Project: 42 Caversham Road
London, NW5 2DS

Purpose: Basement Impact Assessment Audit Response

BIA Audit Response

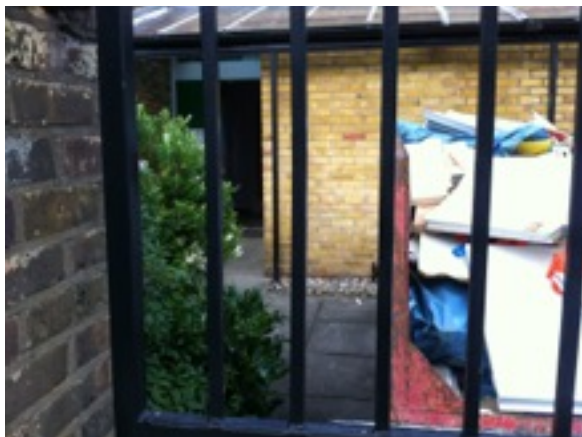
7. ITEM 20

In addition to the evidence provided in the BIA and Ground Investigation Report produced by GEA, we confirm there will be no adverse impact on drainage or run-off and no damage to the water environment.

The existing site is near 100% built on or hard-standing. Please refer to photos of the existing site, below, and Existing Ground Floor Plan, ref: 1217-NMP-XX-00-DR-B-00100, submitted alongside this report.

As shown in the Ground Investigation Report the ground conditions at basement level are clay and so there is no opportunity to have free drainage ground.

The proposed scheme includes a number of green roofs and planters which will reduce the volume of run off. Please refer to Proposed Basement, Ground, First and Second Floor plans to see areas of these green spaces, refs: 1217-NMP-XX-B1-DR-A-00100, 1217-NMP-XX-00-DR-A-00100, 1217-NMP-XX-01-DR-A-00100, 1217-NMP-XX-02-DR-A-00100.

The rainwater collected on site will go through an attenuation tank first to reduce peak runoff into mains sewers.
